RE: Village at Little Falls Environmental Project Review Comments

Project Name and Location:
VILLAGE AT LITTLE FALLS
ROUTE 202, WINDHAM, MAINE

Drawing Name:
GRADING AND DRAINAGE PLAN – SHEET 2

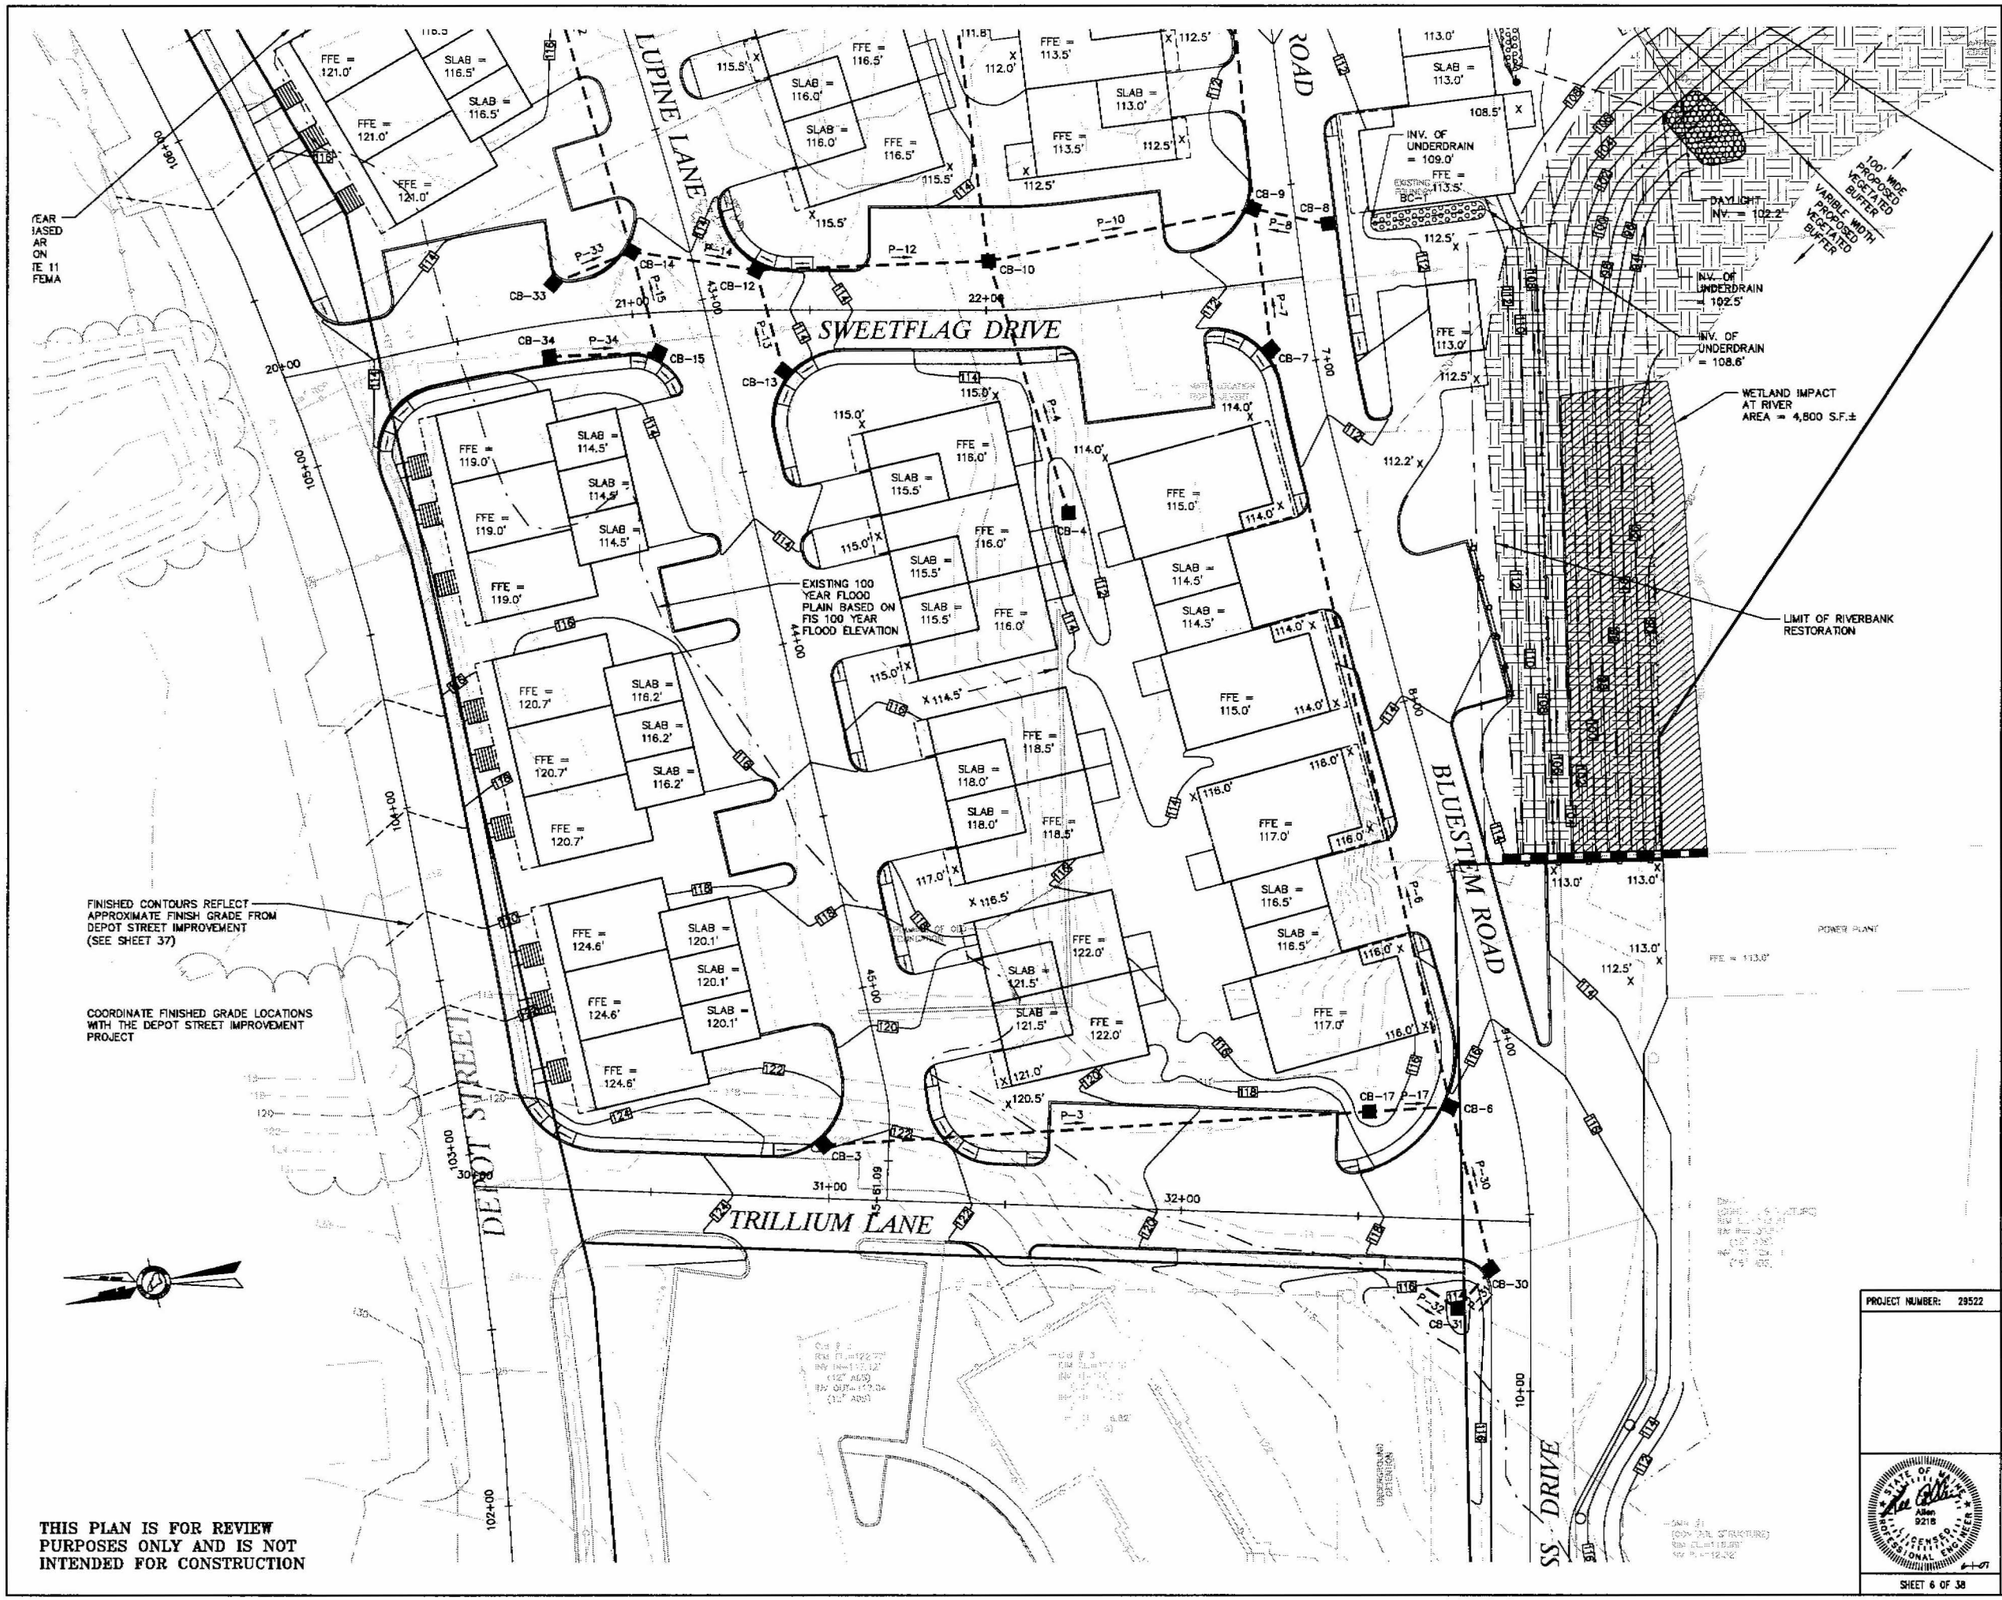
1. Based on the application, I was unclear exactly where and what is included in the buffer restoration plan? While I believe we are on the same page, there should be a specific sheet that clearly depicts the buffer(s), distances, plantings, etc. **Additional hatching has been added to the grading plans in order to help clarify the restoration area. Please refer to Sheet 26 for additional restoration details and a restoration cross-section.**
